**Re: Amend Planning Application pursuant to Section 50 of the *Planning and Environment Act 1987*
Planning Permit Application No. TPM-2019-30
346-350 Macaulay Road Kensington**

We also provide the following detailed written response to respective items raised in the internal referral comments, which will assist in understanding the principles behind the updates to the plans.

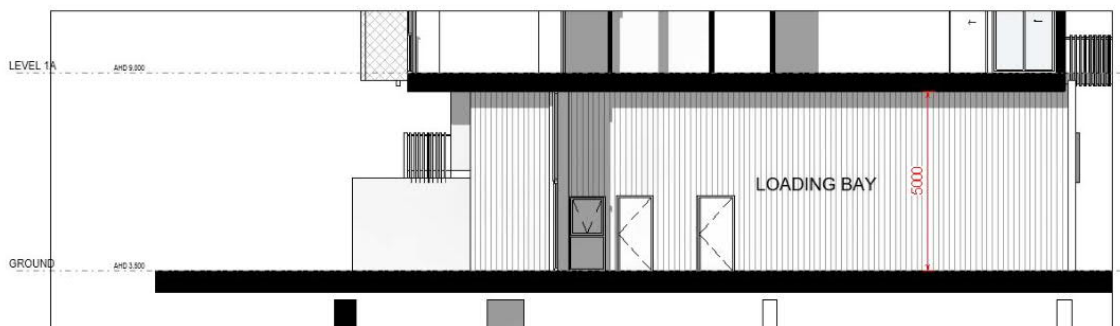
- e) **A sectional diagram showing adequate clearance for the hook-lift vehicle is required.**

A sectional diagram through the loading area (in accordance with what is annotated on TP01.04 Rev 20) as depicted below show the 5 metre clearance for the hook-lift vehicle parked within the Loading Area. We understand City of Melbourne guidelines require a 5.0m height clearance (including away from services/fittings), which can be accommodated.

Image that shows the equanimity achieved across the Macaulay Road interface

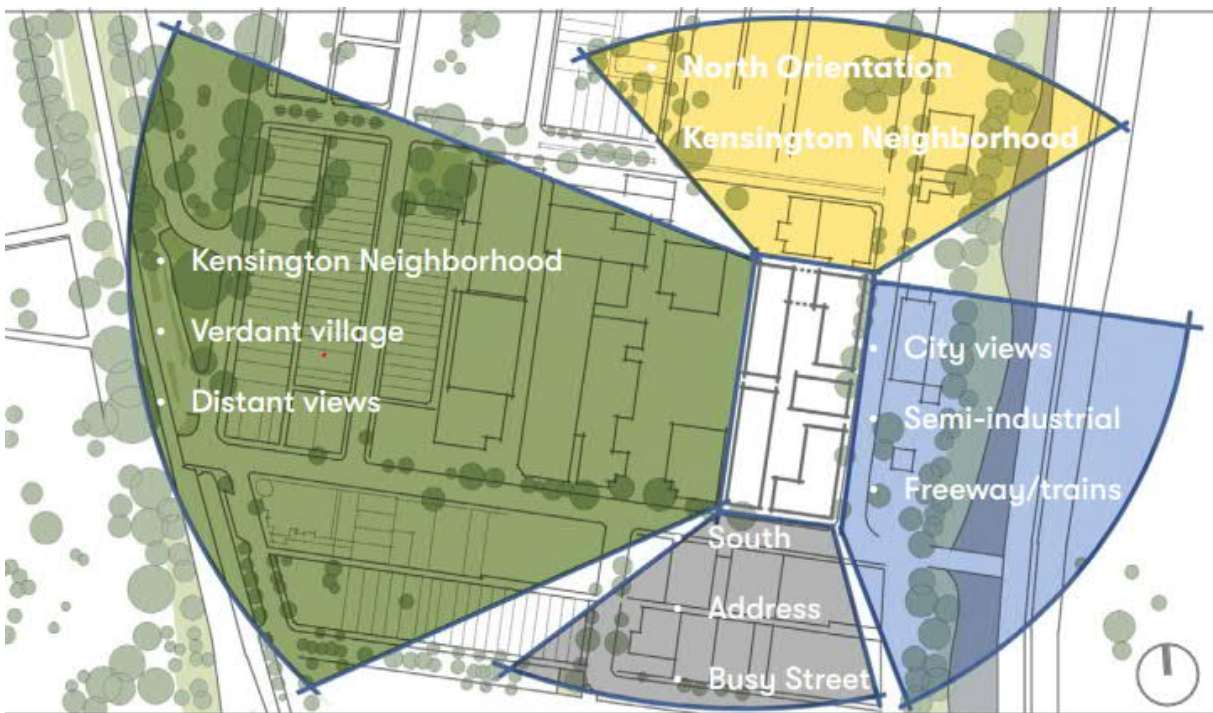
- The 'vertical slit' openings identified by Council's urban design team, are a purposeful architectural response. The smooth, solidness of the street wall at the south-east and south-west corners anchor the building and counterbalance the more sculptural central elements. This is an equanimous design response that we submit is, on balance, an acceptable and equally legitimate planning outcome where considerable competing benefits and challenges are appropriately resolved.

The layout was designed to afford residents views across Kensington Village, to capture oblique northern light but also to allow for surveillance of the southern end of the pedestrian link. The southwest Macaulay Road corner has nevertheless been revised to flip apartments A103, A203

and A503 as requested to open the 'defensive side' and provide a balcony on the south-western corner (TP01.06 Rev 15, TP01.07 Rev15, TP01.08 Rev 15, TP06.02 Rev 6).
